ADDENDUM #3
BL021-26, Gwinnett County East Side Precinct Parking Lot Improvements Project

QUESTIONS & ANSWERS:

C100

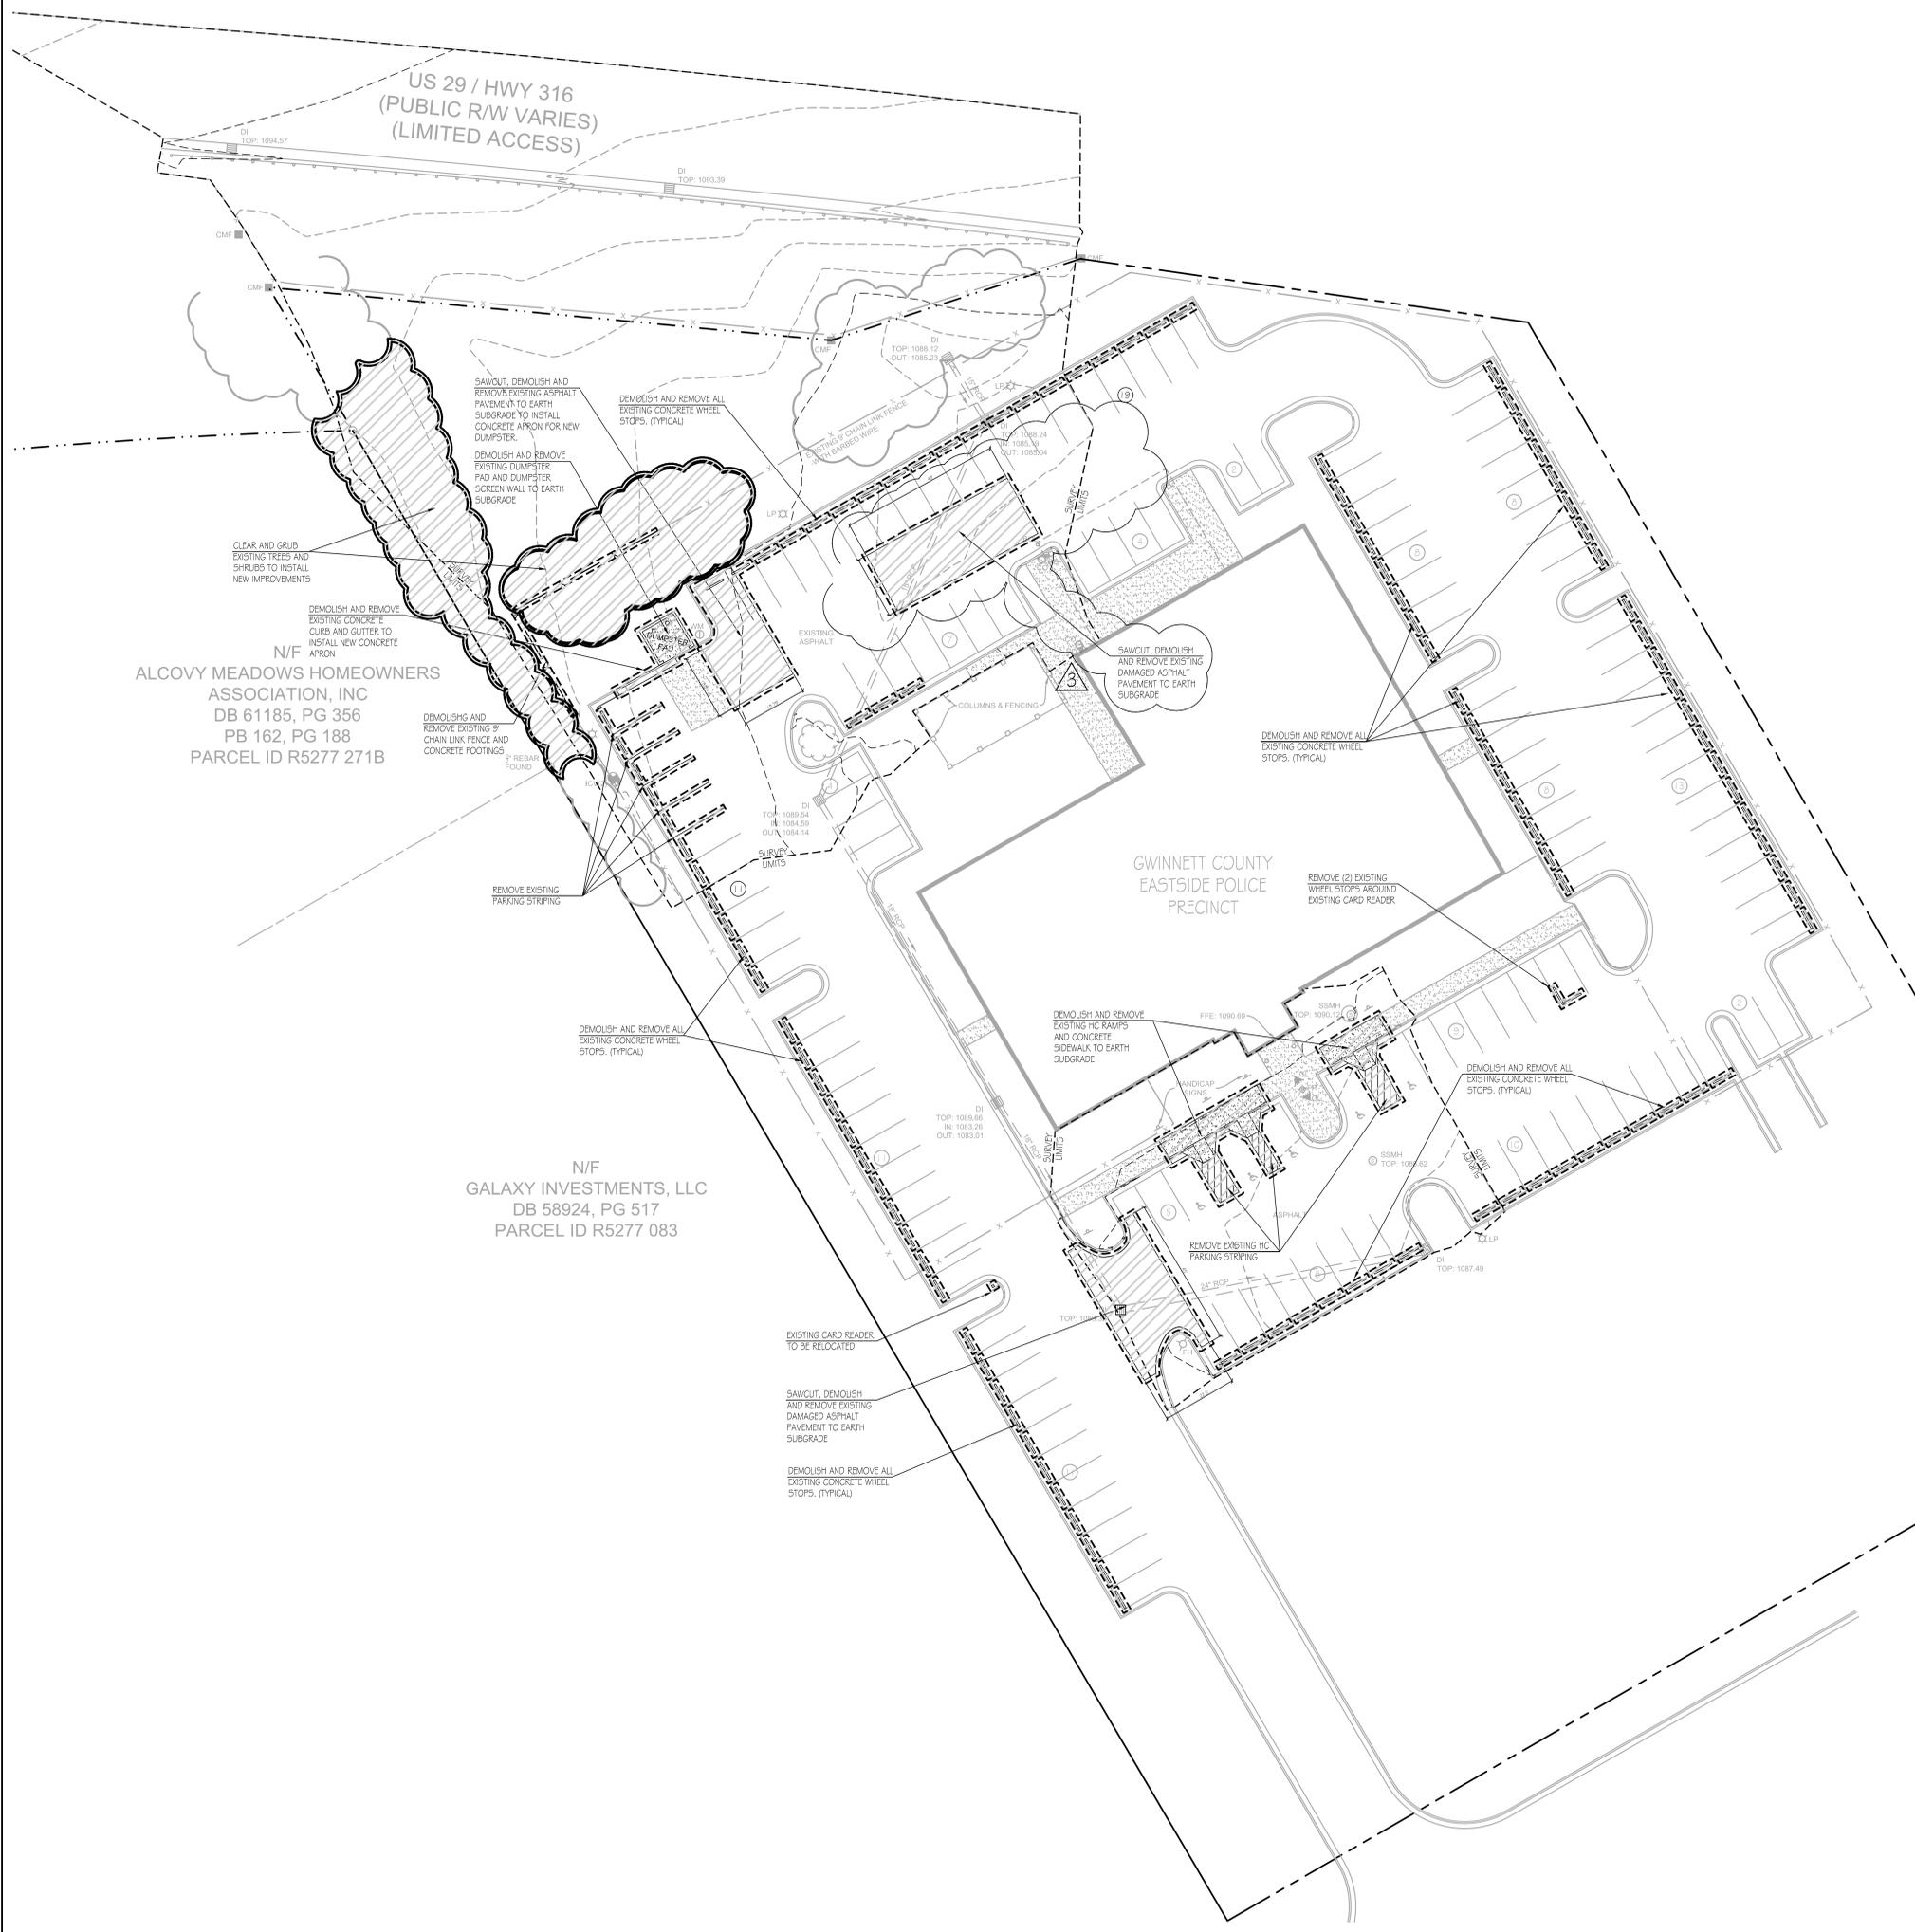
- Q11.** *Per drawing C-100; there are total of 3 locations for Asphalt FDR replacement sections. Since those sections are fairly small enough for to use the Paver machine, which would have to be done by skid loader and hand/labor finish of asphalt. Please confirm.*

RESPONSE: *Means and methods is by the GC.*
- Q12.** *On drawing C-100; plan calls for removal of existing striping in front of Ramps, parking striping; please confirm the removal of existing striping by Grinding method is allowed/acceptable.*

RESPONSE: *Yes. Removal of existing striping by grinding method is allowed.*
- Q13.** *How thick concrete is to be placed/constructed for removal Concrete Sidewalk & Ramp?*

C200

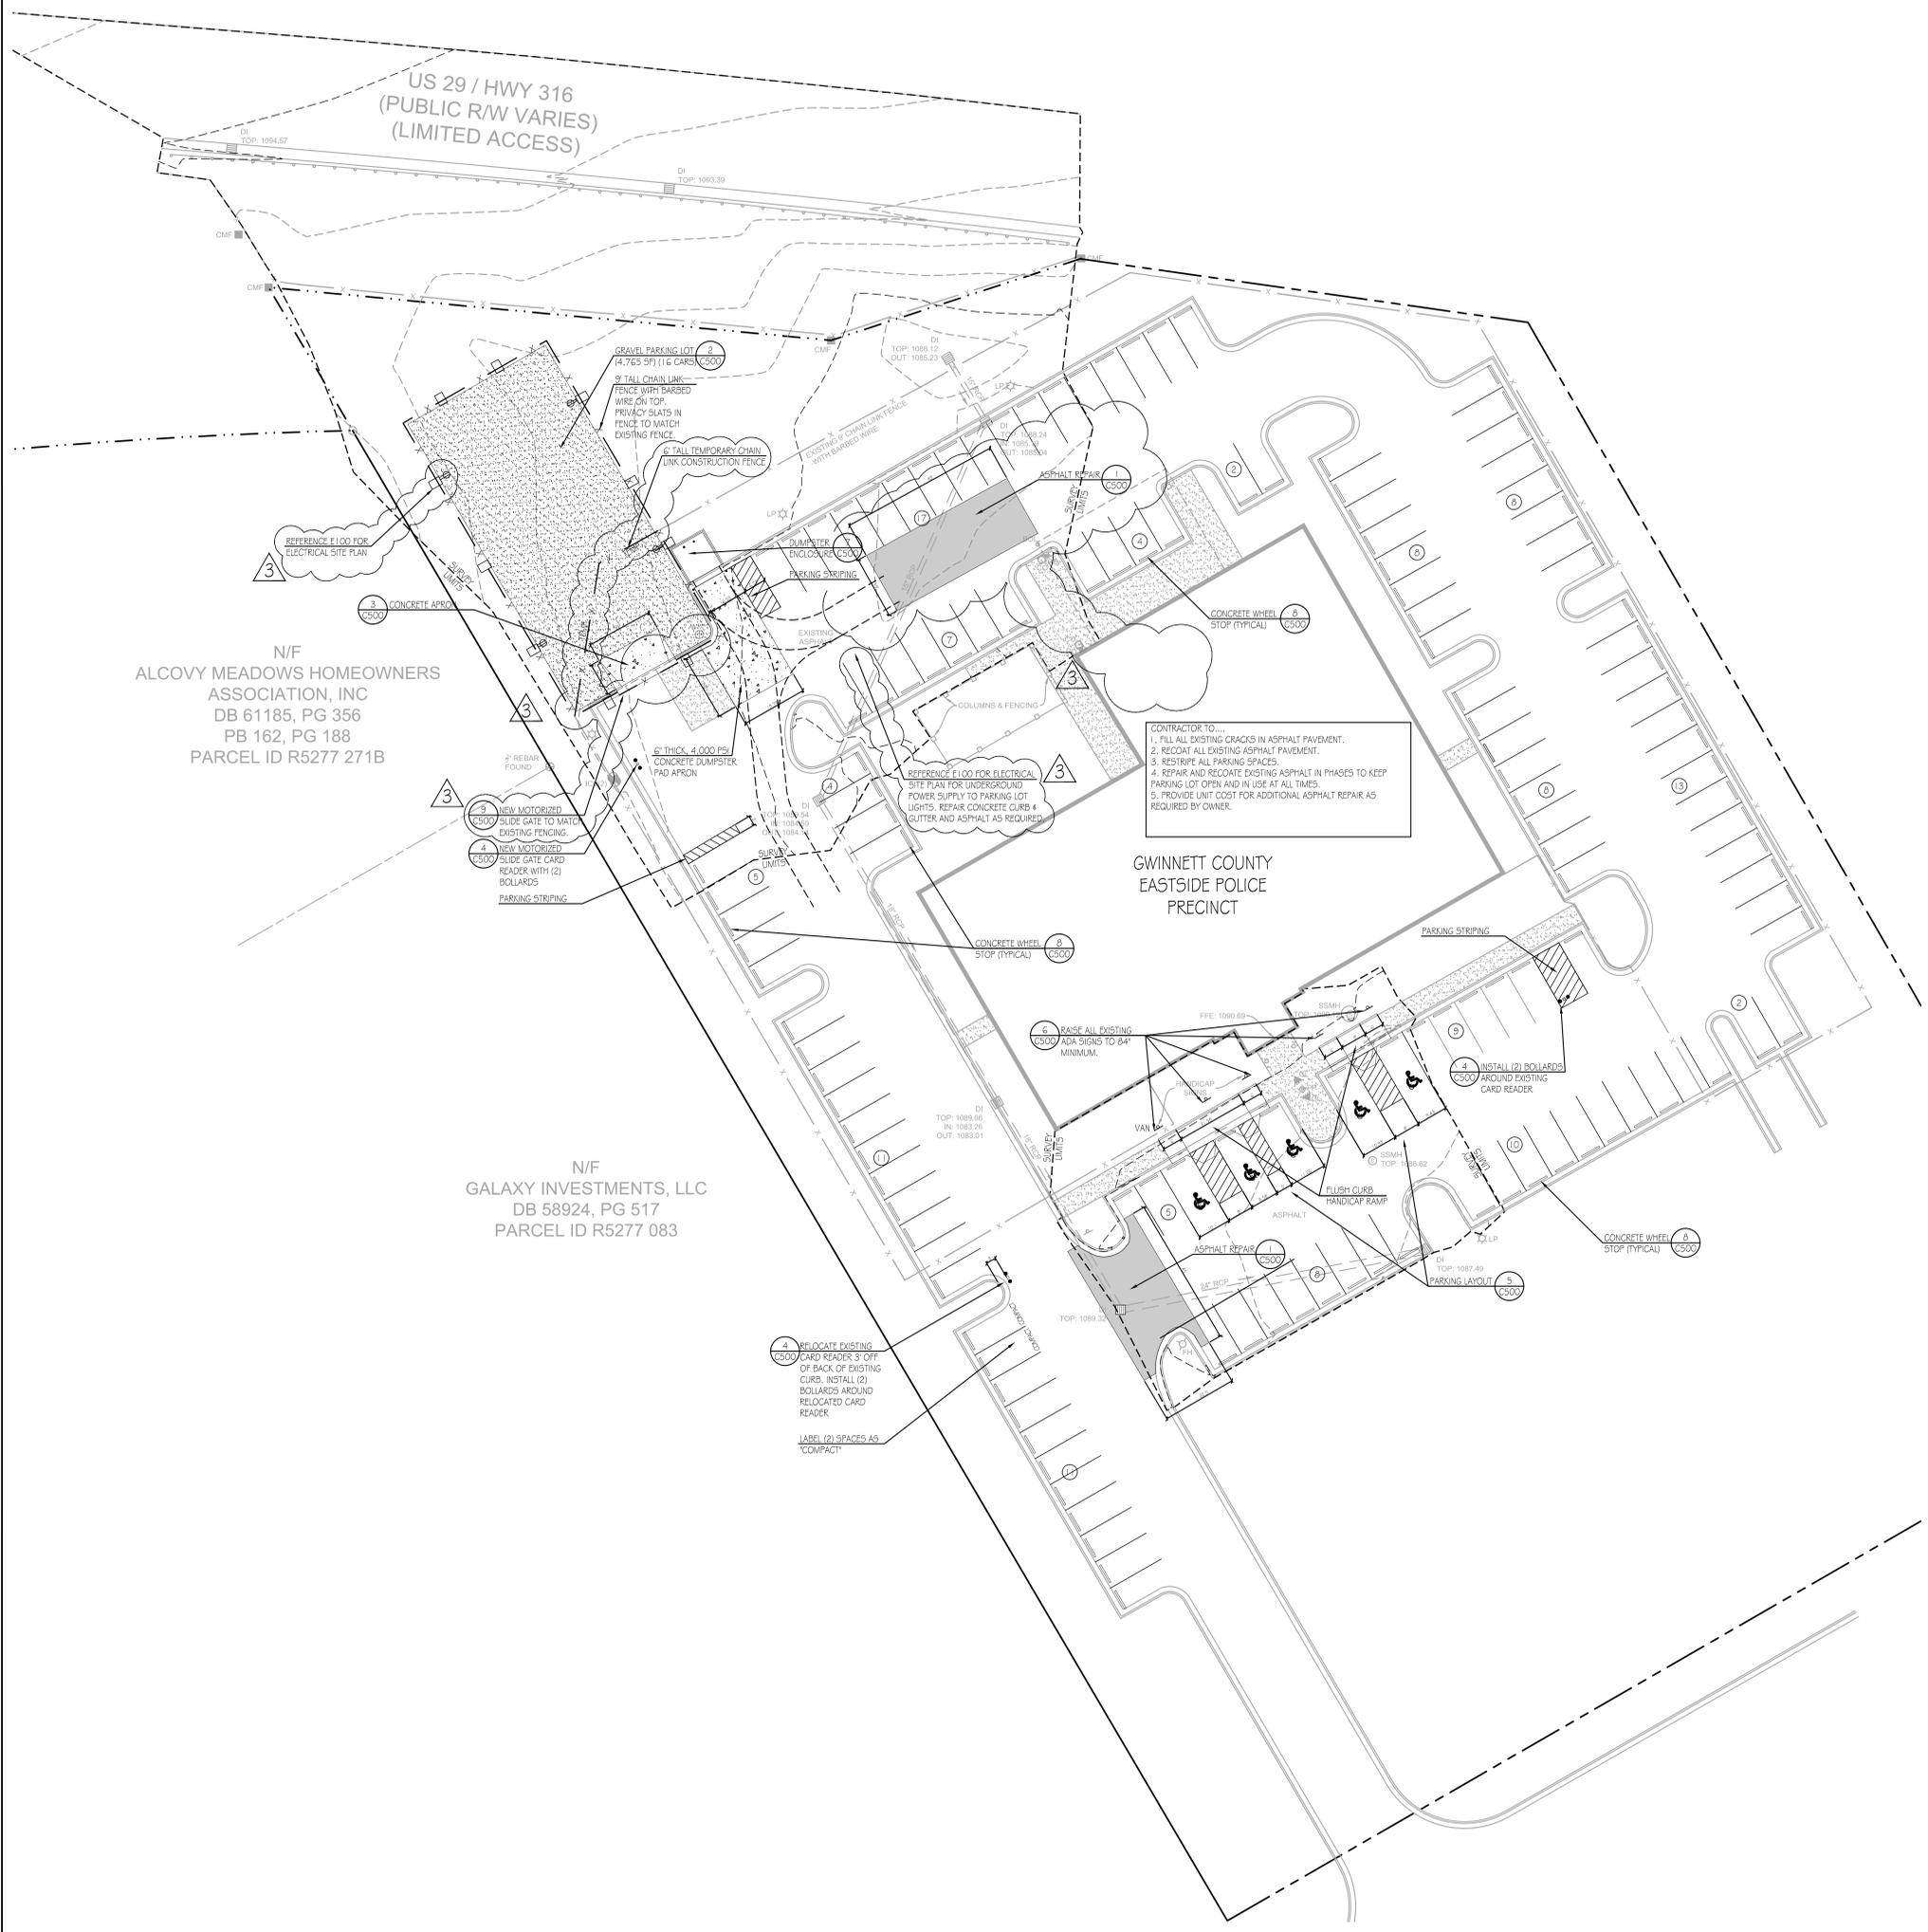
RESPONSE: *See Detail 2 on Sheet E100.*
- Q15.** *Please confirm that in order to begin the construction on back side of Dumpster area for new Parking lot construction; the existing chain link fence will need to demolished first and until the final installation of new fence is completed, the access through backside/new parking lot will be open and accessible all the time.*

RESPONSE: *6' tall temporary chain link construction fence shown on C200 per Addendum #3.*
- Q16.** *Per sheet C-200; plan calls for raise all existing ADA signs. However, the existing signs heights are less than 84" inches which would required to install new post. Please confirm if new Signs and post can be installed in place of Raising existing signs?*

- Q19.** Please clarify how Engineer is requesting/needng the Unit price for additional Asphalt repairs? Additionally, how this price needs to be submitted in bid since it is a Lum sup bid. Please advise.

RESPONSE: *Yes, new posts will be required.*

RESPONSE: Note 5 on C200, provide unit cost for additional asphalt repair as required by Owner. See Specification Section 01 27 00 Unit Pricing and 000 410 Bidding Form; attached hereto.

7 DUMPSTER ENCLOSURE
C500 NTS

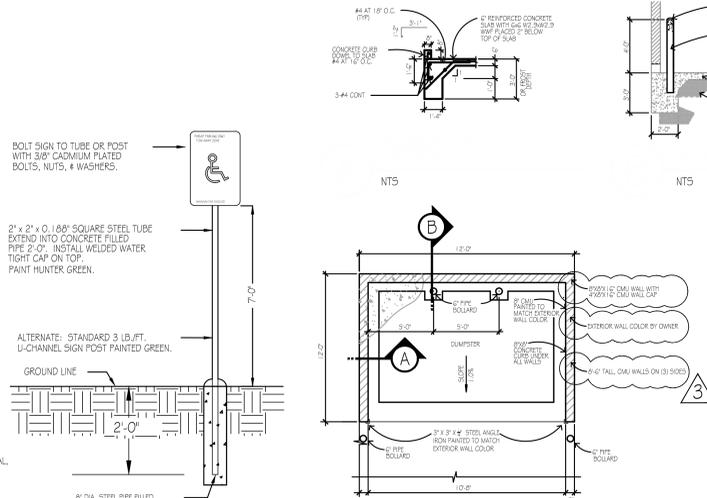
- Q8.** *The Construction Details (C500) show an 8" CMU dumpster enclosure with a concrete slab, but do not clearly indicate the number of dumpsters to be accommodated or the gate type required. Can the County confirm both?*

- Q23.** Please provide complete details/drawing of Dumpster wall including the dimensions of height. Also, please confirm the existing Dumpster and it's walls needs to be completely demolished.

RESPONSE: *No, conduit required. May need it for future use.*
- Q44.** *Please provide specific details or requirements of proposed Dumpster Enclosure Wall including any painting of wall required.*

- Q49.** *How is the dumpster enclosure treated? What kind of cap is required?*
RESPONSE: *Reference detail 7 on sheet C500 Addendum #3.*
- Q50.** *Do the parking stripes get seal coated over?*

RESPONSE: *Yes. No edging required gravel parking lot surface.*
- Q54.** *For the dumpster enclosure CMU wall, 7/C500 only provides limited layout dimensions and CMU block type. However, there are no vertical dimensions provided (Wall height), reinforcement/fill grout requirements, wall cap required?, directions for steel angle specs/installation and/or paint manufacturer /color code specs. Please advise.*

RESPONSE: *Dumpster just like existing, no gate required on proposed dumpster enclosure per Owner.*
- Q9.** *The Site Plan shows two asphalt repair areas but does not include square footage quantities. Can the County provide an estimated square footage for the asphalt repair and patching scope, or confirm a unit price structure will be used for that line item?*

RESPONSE: Reference detail 7 on sheet C500 Addendum #3. Yes, existing dumpster walls and footings need to be completely demolished to earth subgrade.
- Q24.** Please provide complete details/specification of New gate Card Reader & The New Motorized Slide Gate with recommended manufacturer information to ensure it matches the requirements per Engineer's design.

RESPONSE: *Reference detail 7 on sheet C500 Addendum #3*

RESPONSE: *Reference detail 7 on sheet C500 Addendum #3*

9 SLIDE GATE
C500 NTS

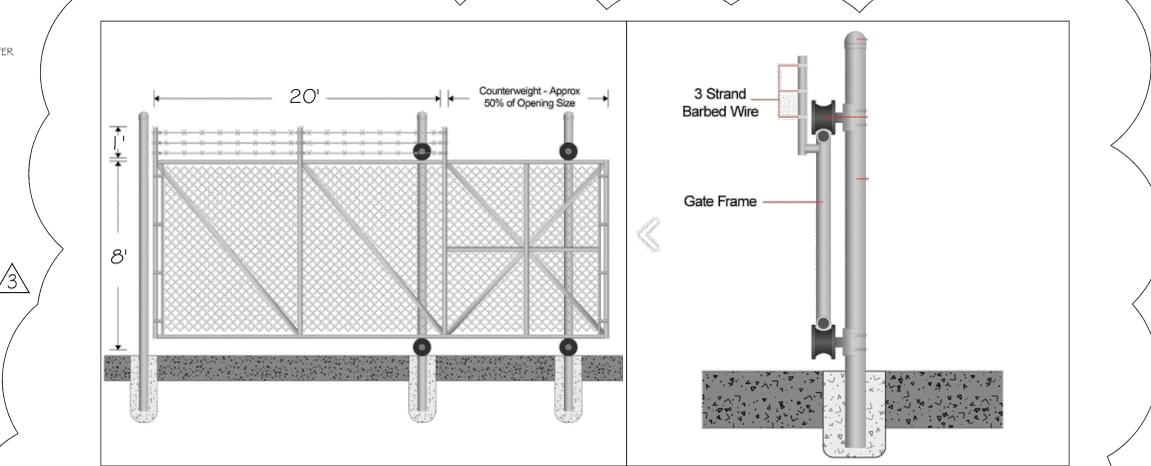
- Q1.** *Is there a detail for the motorized gate and gate slider?*
RESPONSE: *Reference detail 9 on C500 Per Addendum #3 for gate detail.*
- Q2.** *Is there a specified method for running power to the new gate?*

RESPONSE: *This Project is a hard bid project, GC is responsible for all quantities take-offs per the drawings*
- Q6.** *Regarding the motorized slide gate and card reader, are there brand or manufacturer preferences for either? Also, the drawings reference E101 for the underground power supply, but that electrical plan does not appear to be included in the bid set. Can the County confirm power availability at the gate location and provide the E101 plan?*

RESPONSE: **See Specification Section 01 27 00 Unit Pricing and 000 410 Bidding Form; attached hereto.**
- Q32.** *Per Drawing C-200, the new Motorized slide gate to be installed. However, per plan since there won't be enough space for Slide gate for Single door, it appears that it would need to be designed as double door slide gate. Please provide details for the Proposed Slide Gate with Manufacturer's model number along with detailed dimensions in order to install on this project.*

RESPONSE: *Route CAT6 cabling back to IDF Rm for control. Contractor required for installing and programming card reader with owner training.*
- Q40.** *Please provide the details of Card Reader (specific brand, model number, specification etc.).*

RESPONSE: *Civil Plans updated per Addendum #3 to call out reference to E100. Power must be provided to new gates per Note #7 on E100. Card reader and gate to match existing gate manufacturer.*

RESPONSE: Reference detail 9 on sheet C500 Per Addendum #3. Card reader and gate to match existing gate manufacturer.
- Q25.** Please confirm the Gravel to be installed in proposed parking lot can be used as Graded Aggregate base (GAB) or Aggregate surface course as approved material.

RESPONSE: **Reference detail 9 on sheet C500 Per Addendum #3. Card reader and gate to match existing gate manufacturer.**
- Q33.** *Please confirm the existing Concrete pad of Dumpster located in Parking lot to be remain in place as is and It's not required to demolished/paved back with new asphalt.*

RESPONSE: *Reference detail 9 on sheet C500 Per Addendum #3. Card reader and gate to match existing gate manufacturer.*
- Q41.** *Since plan calls for 2 locations for FDR of Asphalt in parking lot, Contractor recommends to complete both locations for Asphalt work in one mobilization only; by having/helping with flaggers for any traffic control needs for temporarily in order to complete work in one day. Is this acceptable?*
